ADDENDUM No. 1

ITB No. 4753

Miller Avenue Rehabilitation

MILLER AVENUE TYPICAL SECTION STA. 63+85 TO 68+75

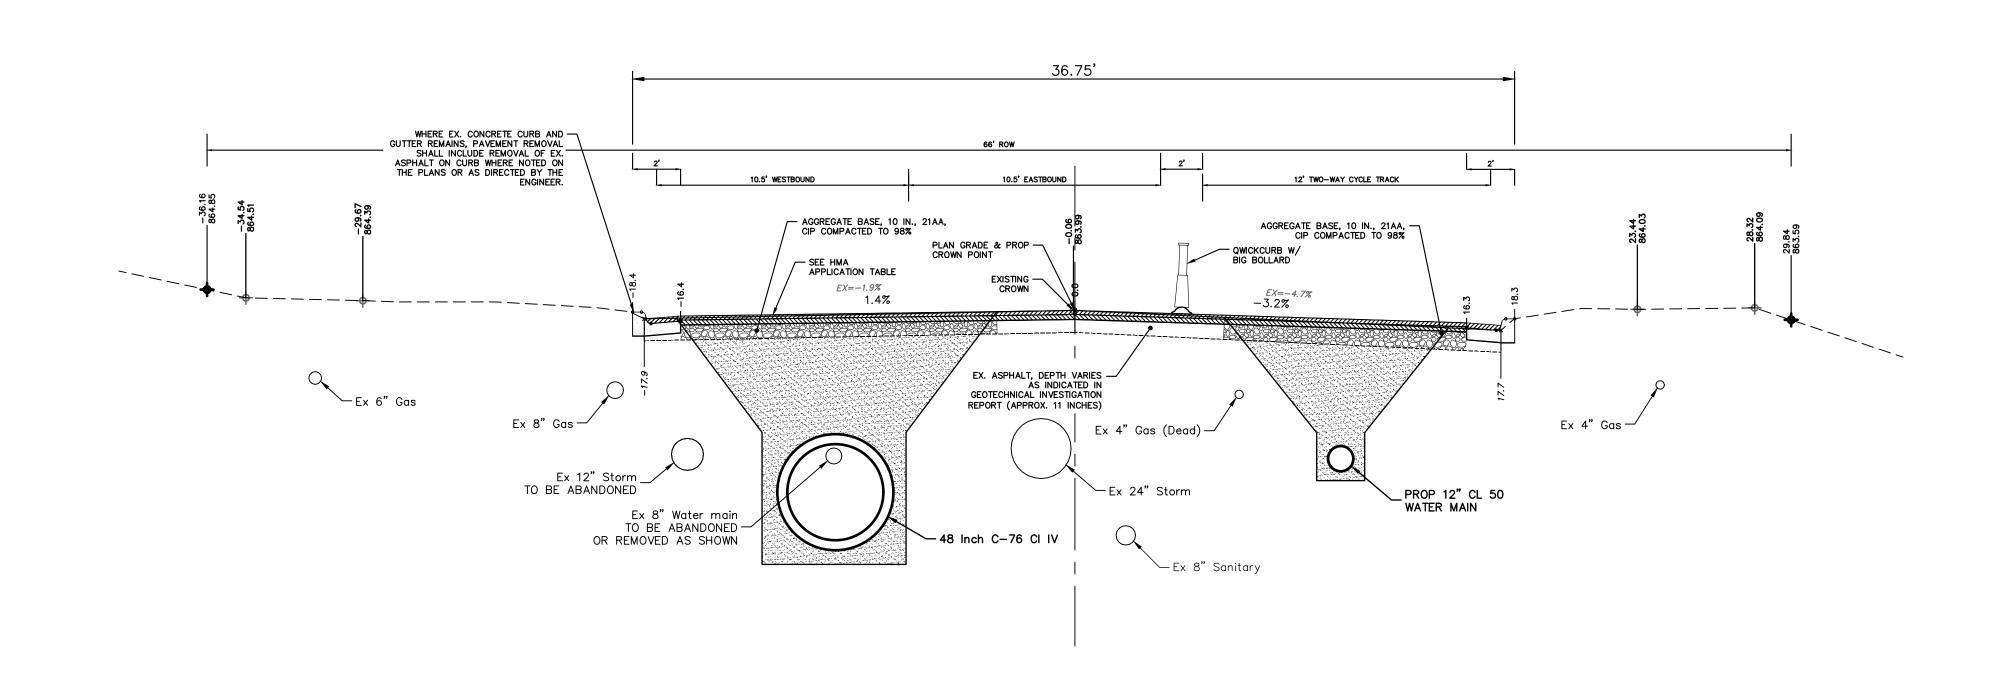
- Question 15: Is the excavation as may be required between STA 79+00 and the POE to be incidental to 4" aggregate base, or will it be paid separately? Notes on the typical cross sections are not clear.

- Answer 15: This excavation will be paid for as indicated on the revised cross sections.
- Question 16: Please confirm that "Turf Establishment" will be paid for as "Turf Restoration". See notes on typical cross sections.

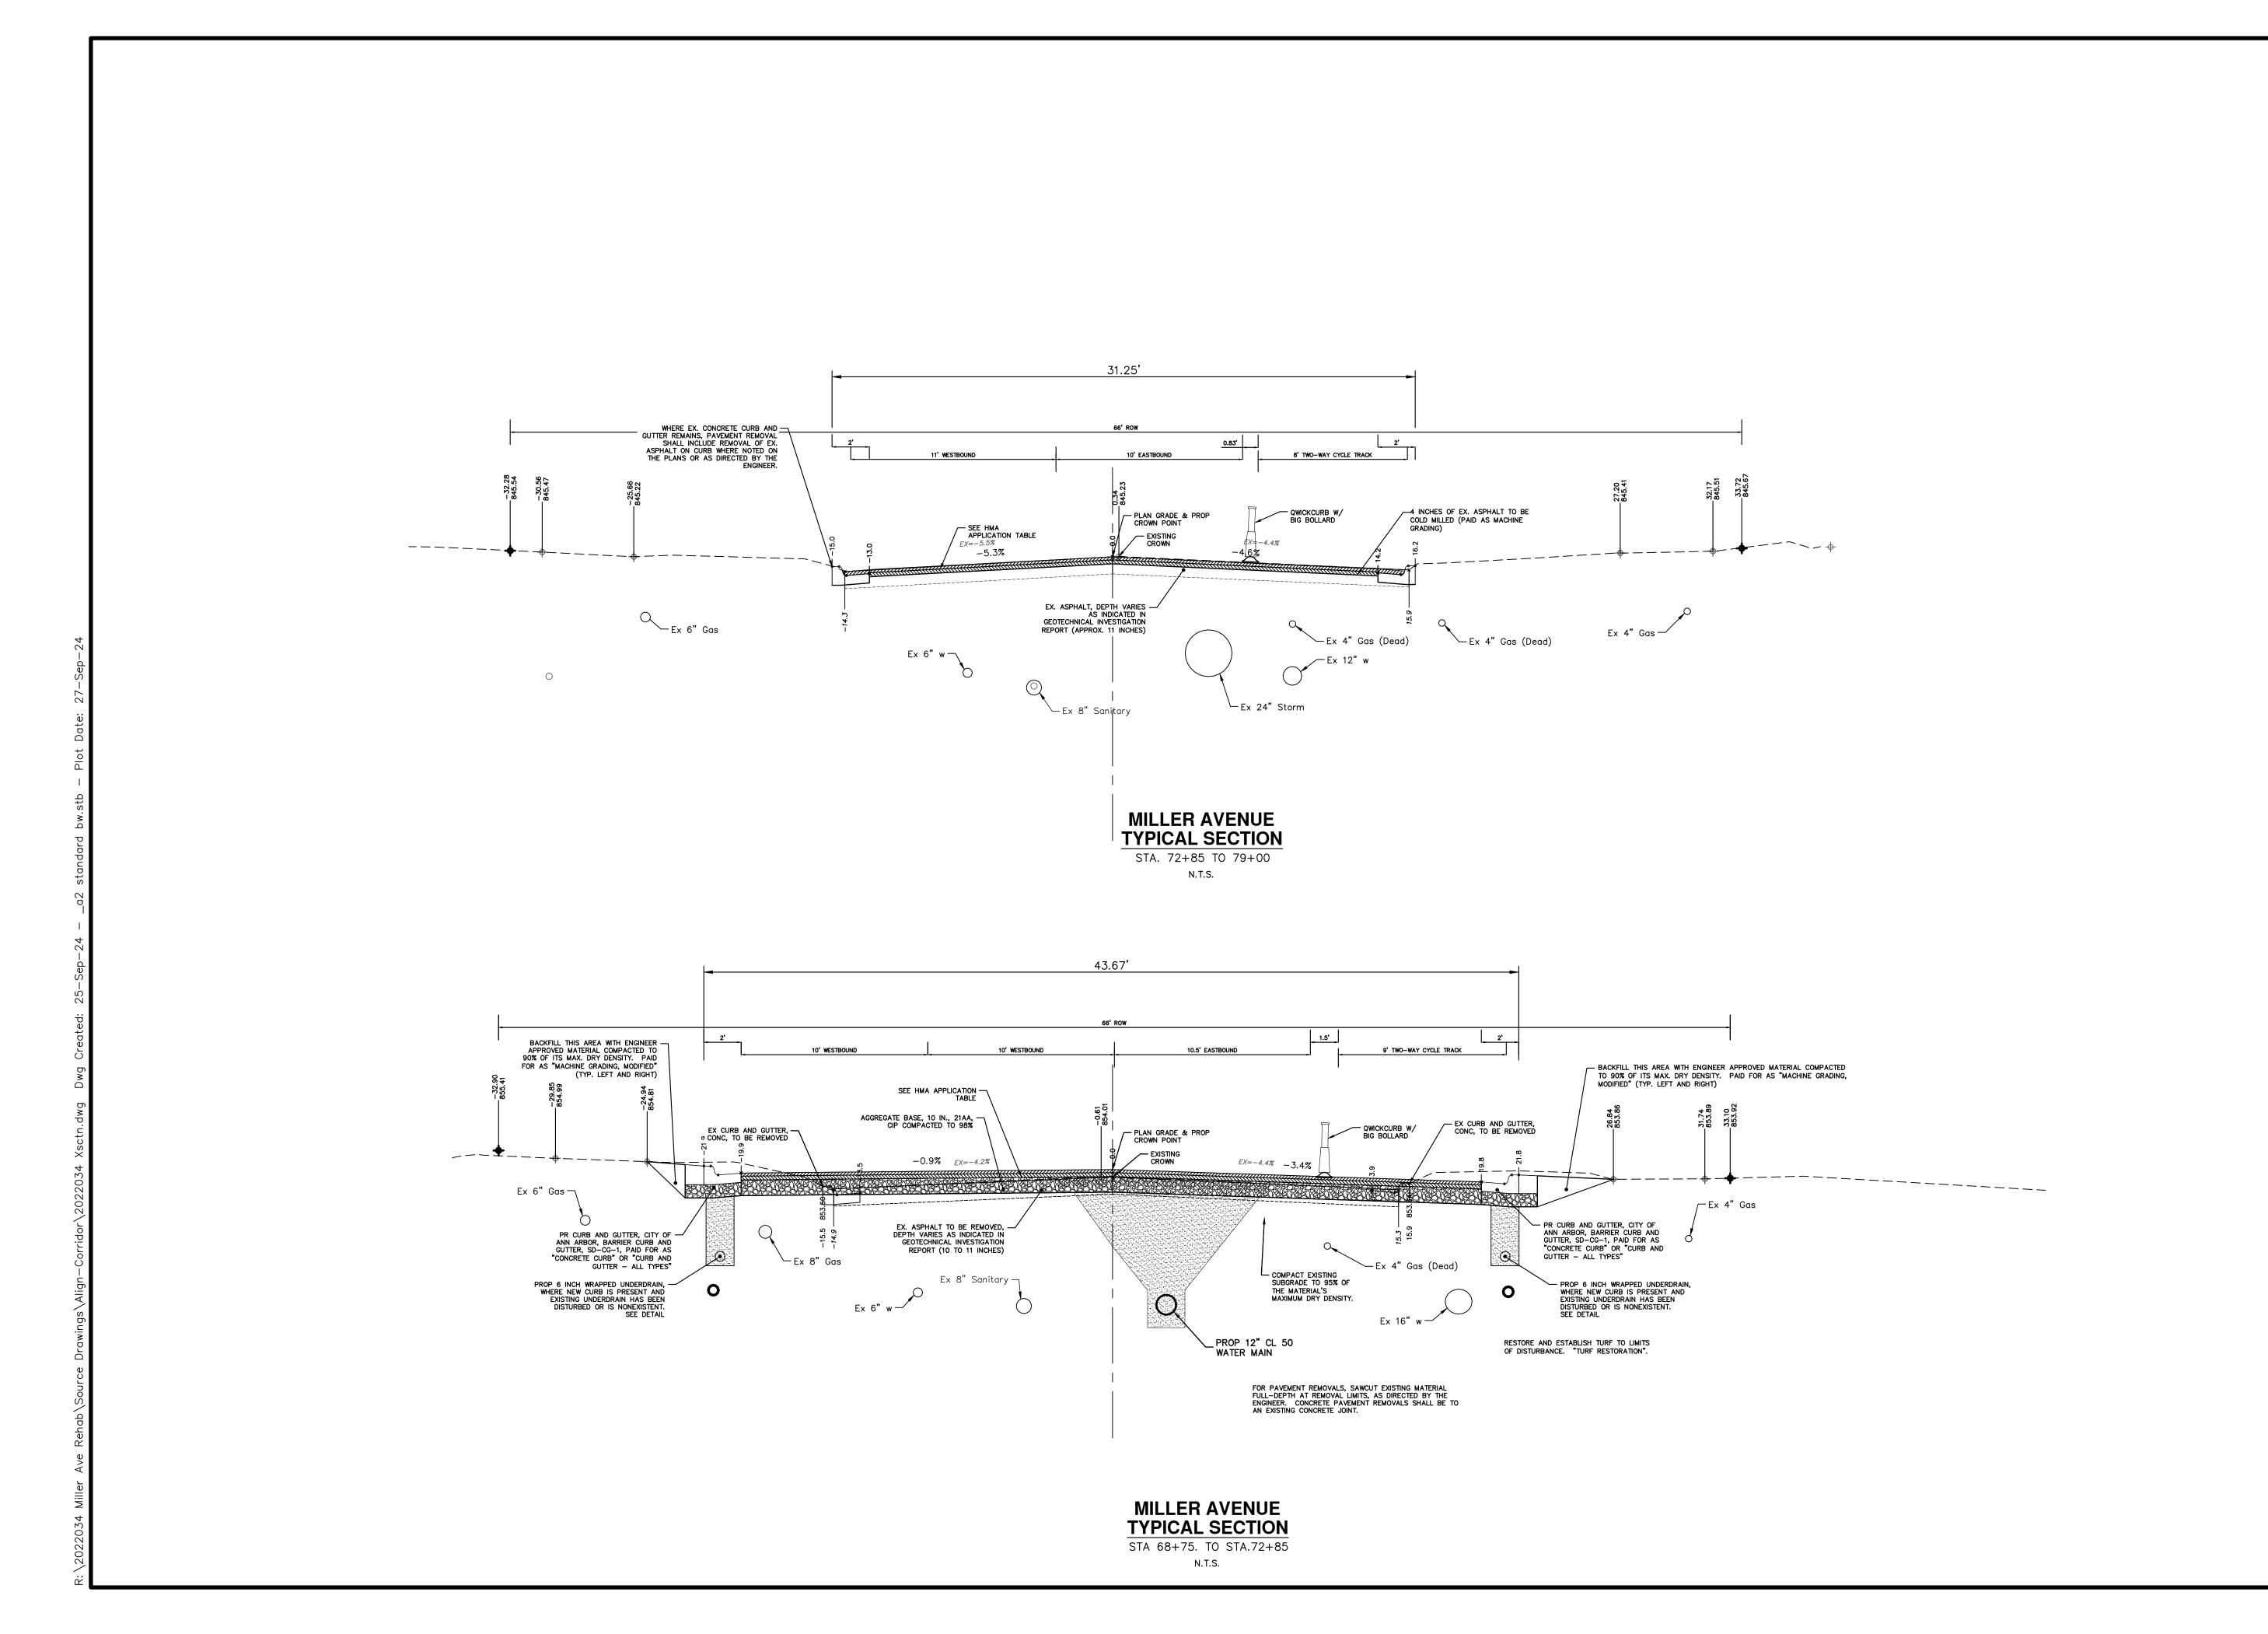
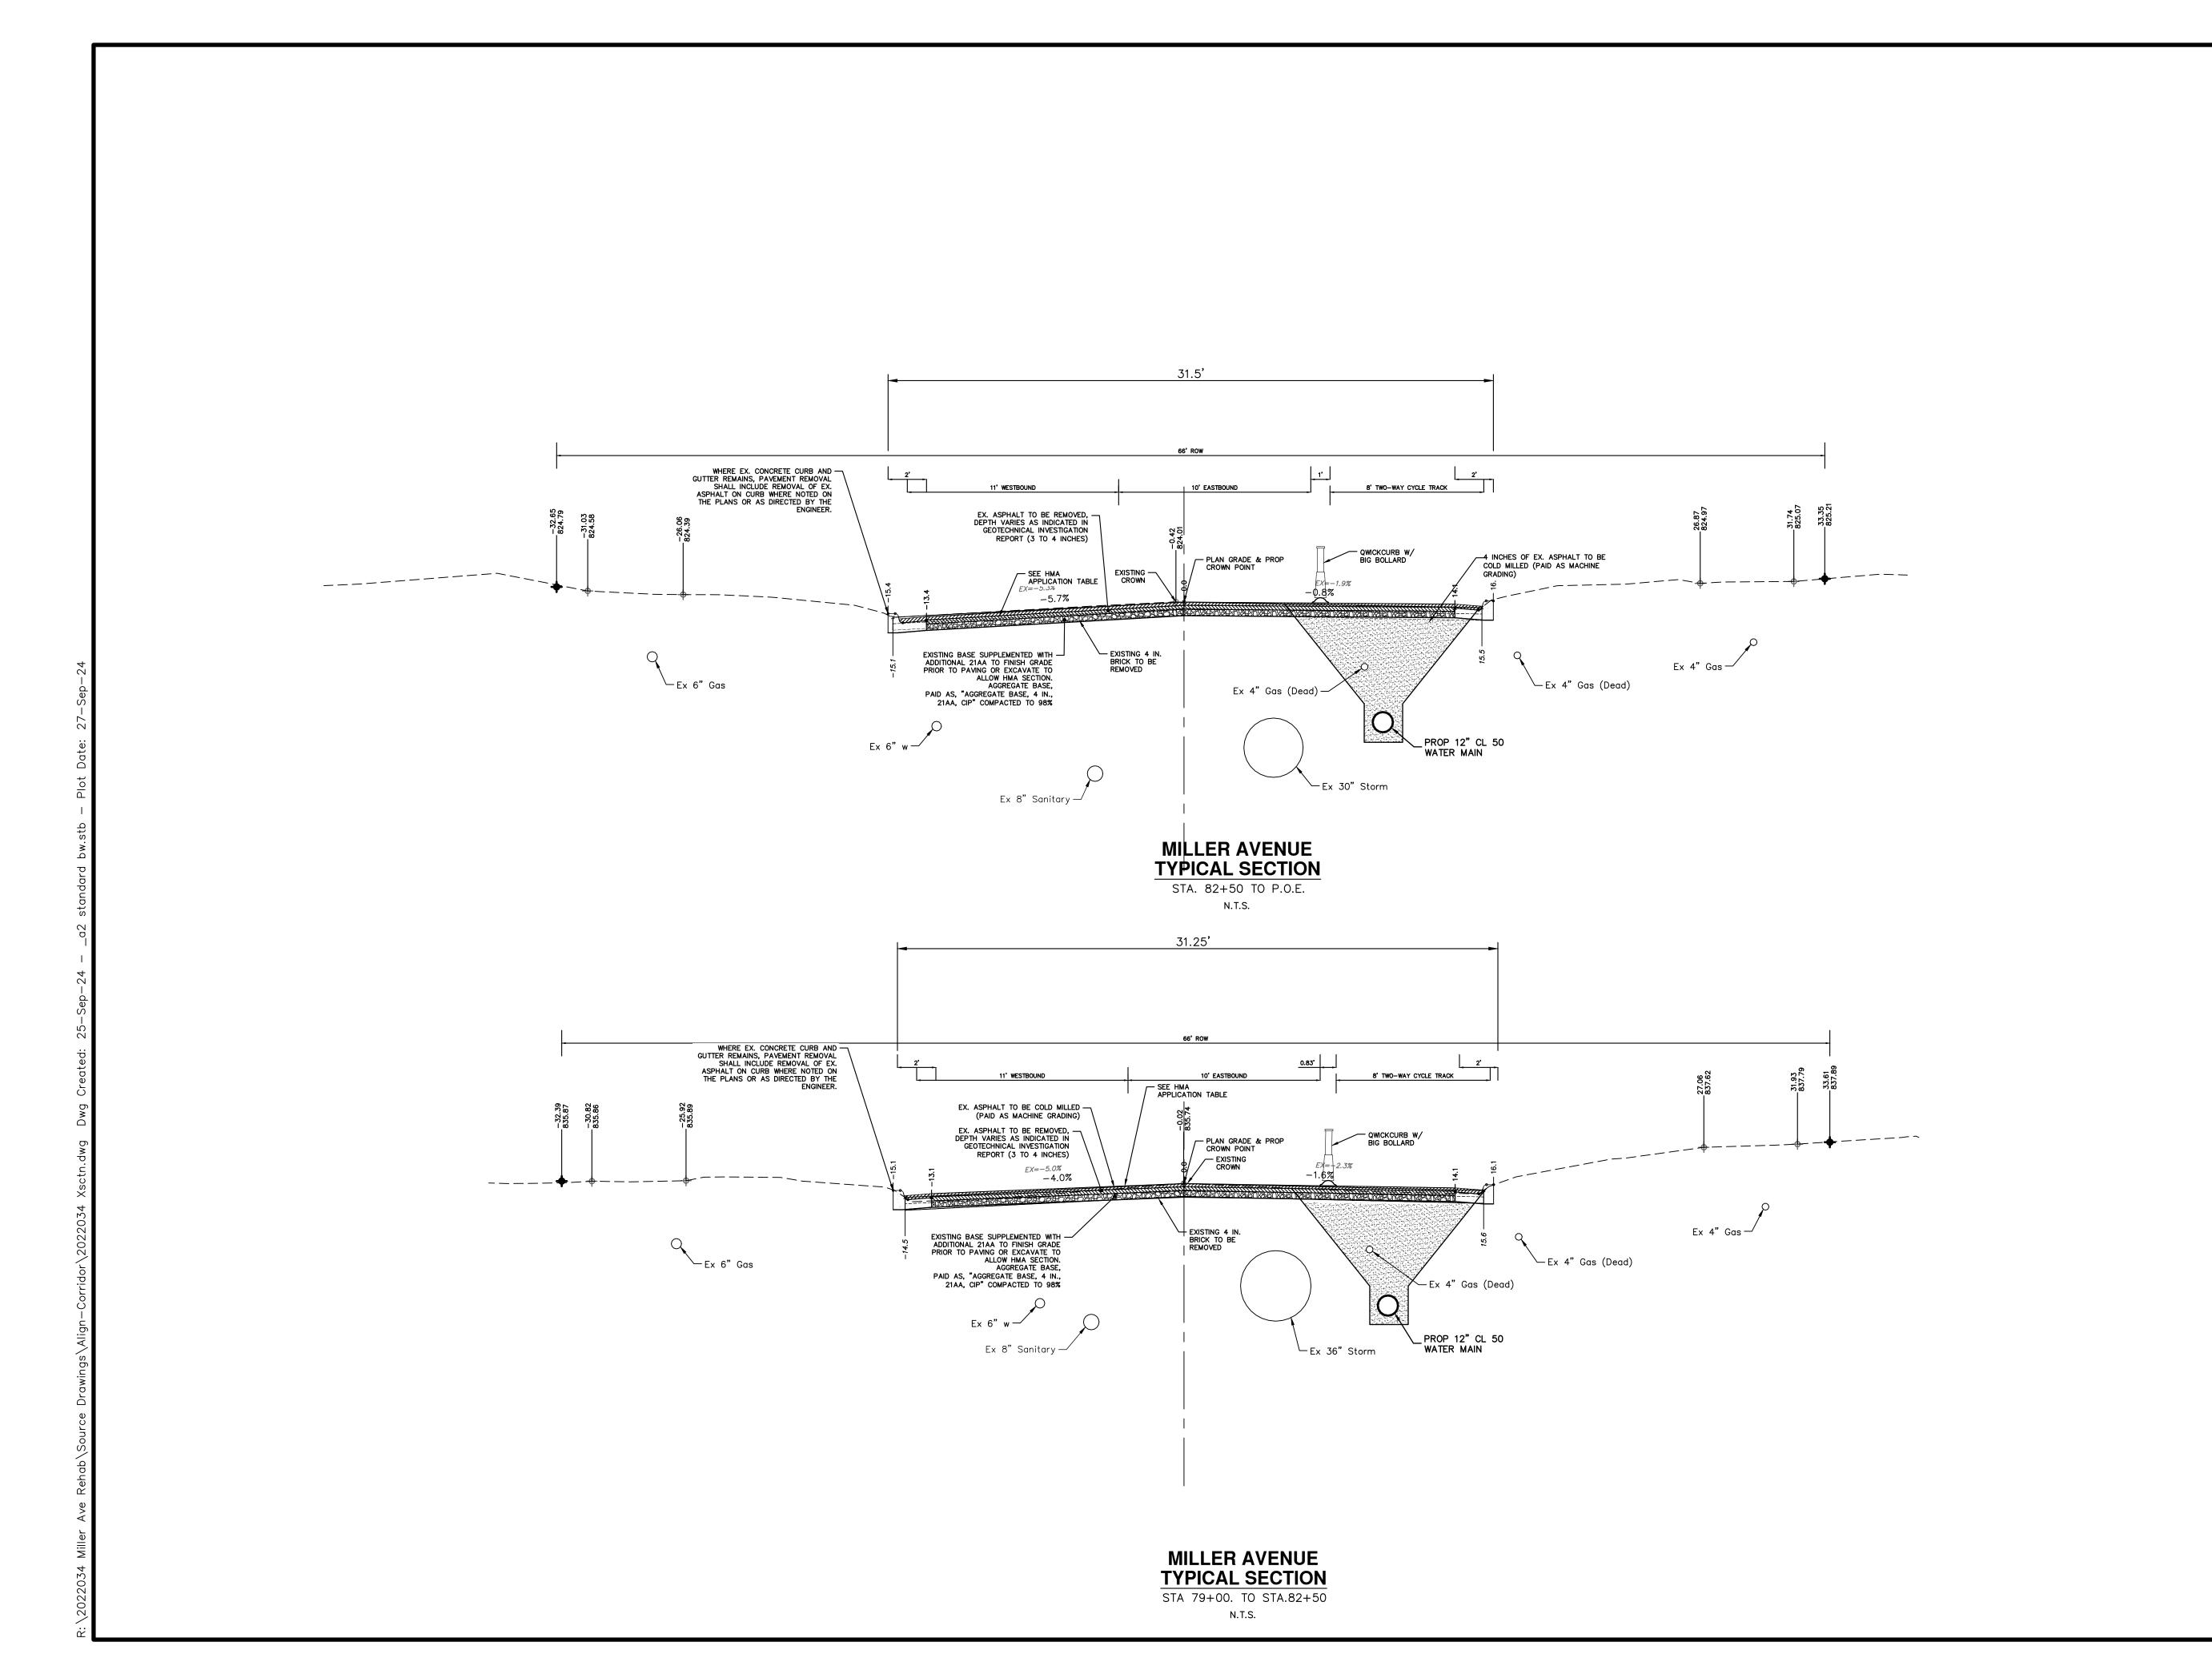
All mentions As provided in ITB No. 4753 Plan Set pages 18, 19, 20 and 21:

Comment: The intent with this change is to simply replace the inaccurate Pages 18 through 21
